**MAYBURY PARK ESTATES –
ENTRY GATES PHASE 1 AND 2
(AMENDED RESIDENTIAL UNIT
DEVELOPMENT - R.U.D.)
SP 08-14A**

PLAN REVIEW CENTER REPORT

SP #08-14A

Amended Residential Unit Development (RUD) and revised Preliminary Site Plan (two-phases) to add gated accesses and change the existing, approved RUD plan to permit the roads to be private rather than public

RVSD ENTRY LANDSCAPE
Maybury Park Estates: Phase I
 Novi, Sec. 32, T. 1N, R. 6E., Michigan

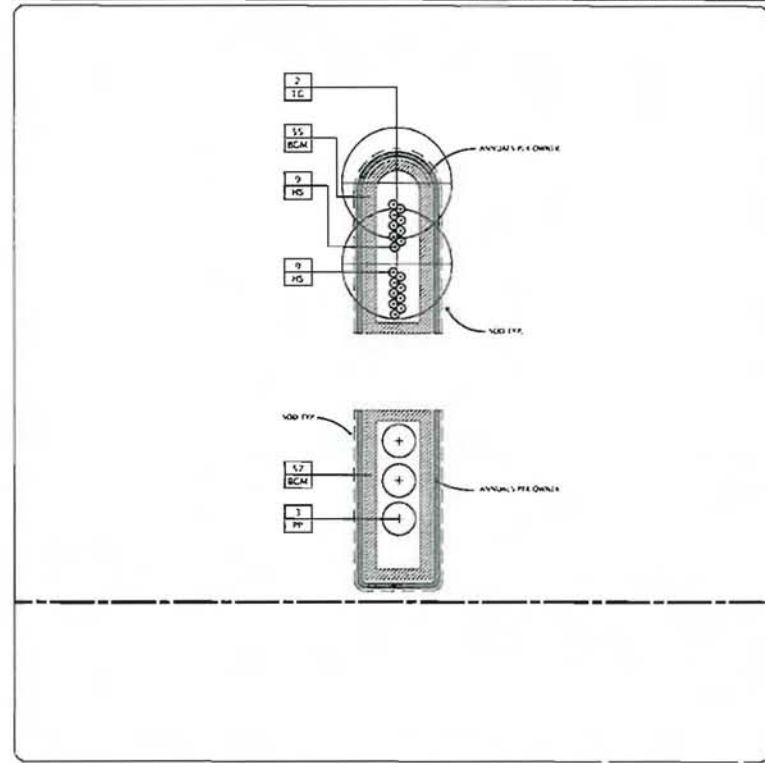
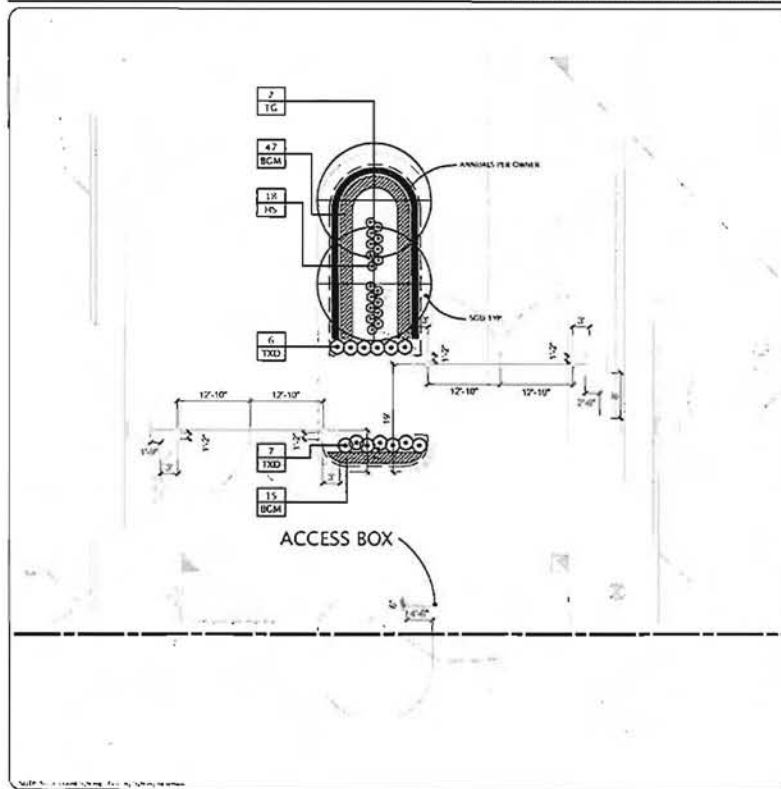
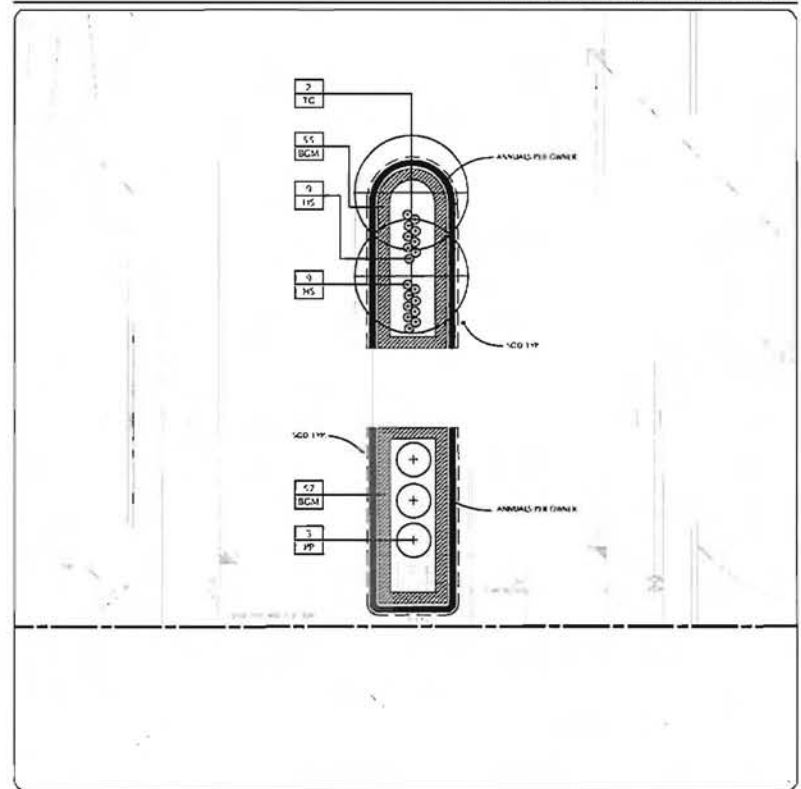
The installation of the entry gates as proposed does not significantly affect the landscape design as originally approved. **Staff supports Planning Commission approval of SP#08-14 Maybury Gates,**
